Service Bulletin No. 063

Alternator Models ALT Belt & ALX Gear Series HET P/N ALA-0020G Through Bolt Replacement

Figure 1 - Belt Drive Alternator Pan-Head Through Bolt Head Separation Example (Shown with Fan Removed)

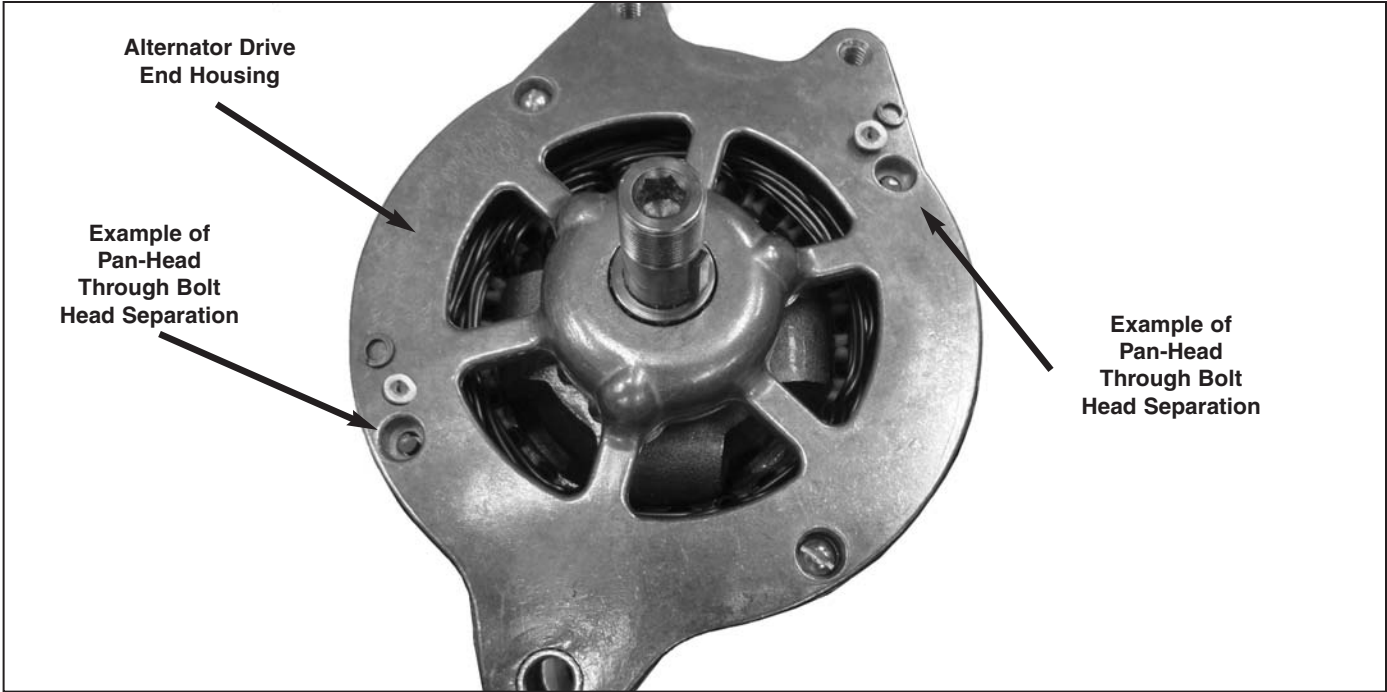
- (1) Affected serial numbers of model ALT and ALX series alternators may have a pan-head style HET P/N ALA-0020G through bolt installed. These pan-head through bolts have had incidences of bolt head separation. Refer to Figure 1.
- (2) To eliminate the risk of through bolt head separation, all pan-head through bolts must be replaced with HET P/N ALA-0020G fillister-head style through bolts on the affected alternators. Refer to Figure 2, Figure 3, and Figure 5.
- (3) The pan-head version of the HET P/N ALA-0020G through bolt is being discontinued and will no longer be used.
- (4) Regulatory action is unknown.

Figure 3 - Through Bolt Head Inspection Example for Belt Drive Shown.

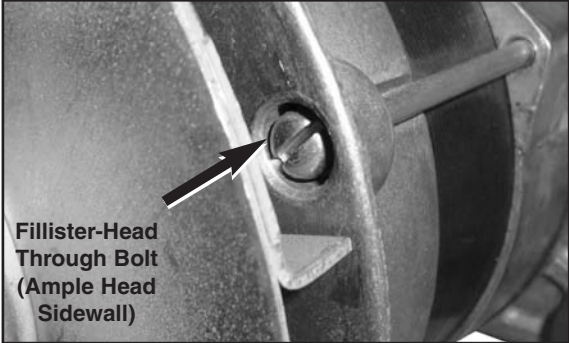
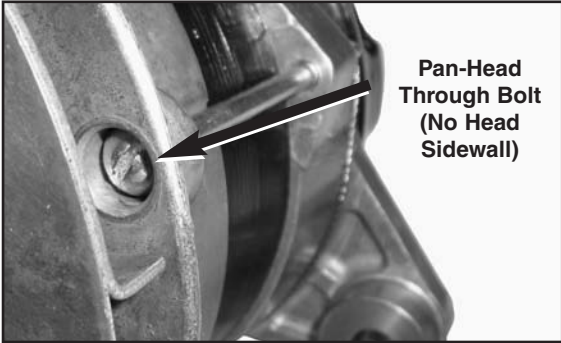
- (1) Using a bright white light, inspect the alternator drive end housing at each through bolt location (four each). Refer to Figure 2 and Figure 3.
 - a. If a pan-head through bolt is installed, return the affected alternator for repair per 3.C, Corrective Action. Refer to Figure 4.
 - b. If positive identification that four fillister-head through bolts are installed, the affected alternator is in compliance with this service bulletin. Proceed to 3.D(3), Return to Service. Refer to Figure 5.
